# SKF Technical Bulletin

## VKPA 84621– Fitting instructions

Ford Mondeo III, Transit, 2.0 and 2.2 TDDI-TDCI engines Jaguar X-Type 2.0 and 2.2 D engines

SKF Fitting Instructions and Kit content evolution

Water pump

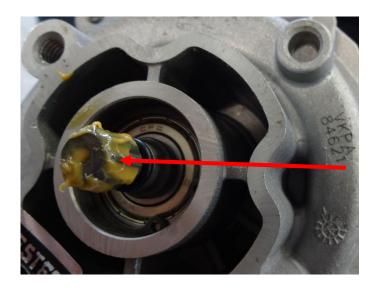
Due to complex mounting process and associated sub components that can affect the performance of the new fitted water pump, SKF has added some extra components into the water pump VKPA 84621 for a complete and professional repair.

#### Extra components added:

- Metal gasket (block cylinder side)
- Premounted O-ring at splineshaft
- O-ring for thermostat housing
- 4 Bolts

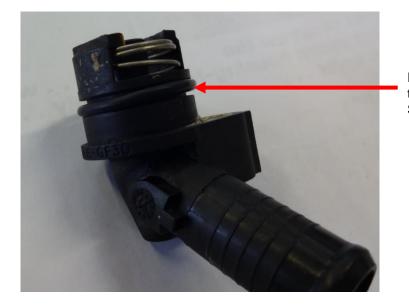
The pump design operates via a spline connection from the power steering pump drive, therefore this component should be correctly greased.

The O-ring must correctly be fitted to prevent wrong contacts and vibrations which could result to the water pump damage and the impeller damage.

Remove the oil temperature control thermostat from the water pump housing and fit the O-ring included in SKF kit VKPA 84621.
